SUBJECT: COMANCHE PEAK STEAM ELECTRIC STATION (CPSES)
DOCKET NO. 50-445
TECHNICAL SPECIFICATION CHANGES

Attached are the marked-up pages of the draft CPSES Unit 1 Technical Specifications and BASES (NUREG 1381) provided with the low power operating license. These marked-up pages reflect changes requested by TU Electric to be included into the full power operating license for CPSES Unit 1. Also attached is a description of these changes. FSAR changes associated with chapter 6, "Administrative Controls," of the Technical Specifications will be provided in a separate submittal.

CPSES TS REVISION 1
DETAILED DESCRIPTION

FIGURE 3.1-1

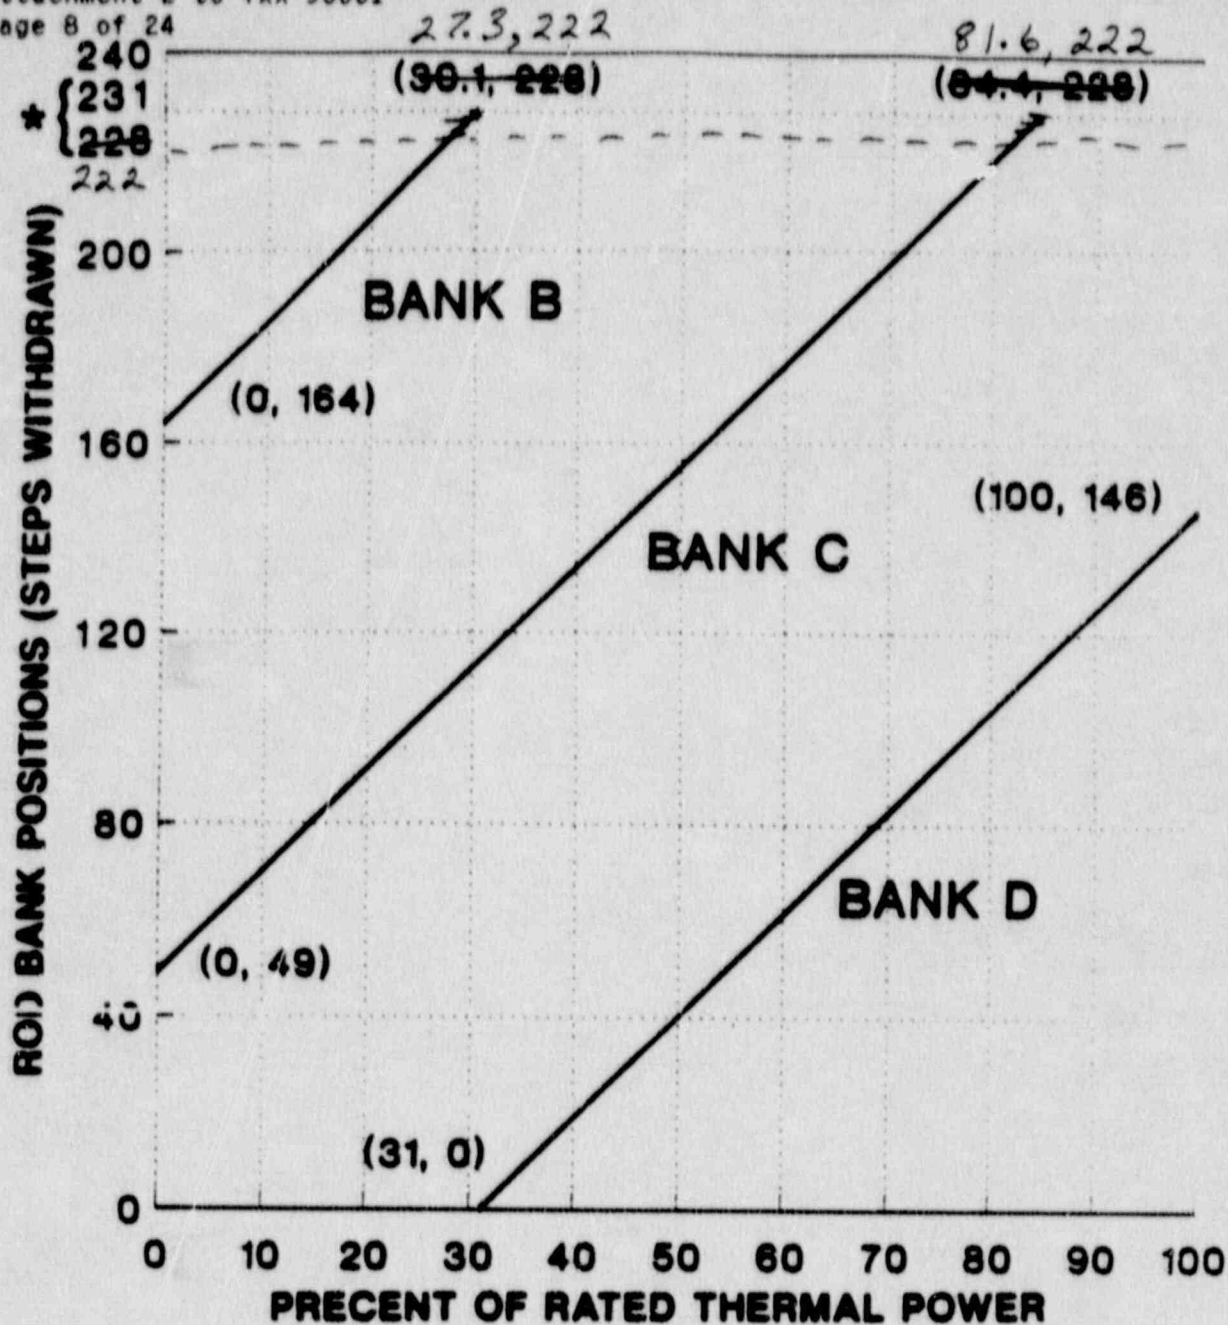
3/4 1-20, 22

- 2 Implementation of Westinghouse recommended control rod wear mitigation techniques.

IE Information Notice No. 87-19 notified Westinghouse facilities of potential for perforation and cracking of RCCAs. The proposed changes to the Technical Specifications allows the implementation of recommended wear mitigation techniques. Similar changes have been accepted by the NRC for the Wolf

Creek facility. Westinghouse has assessed the impact of the change for CPSES and has concluded that the shutdown margin will not be violated and that the MTC values are bounded by values assumed in the safety analyses. Additionally the effect on Fz and Axial Offset is at most +0.5% relative to the all-rods-out calculation (when the RCCAs are parked furthest in the core).
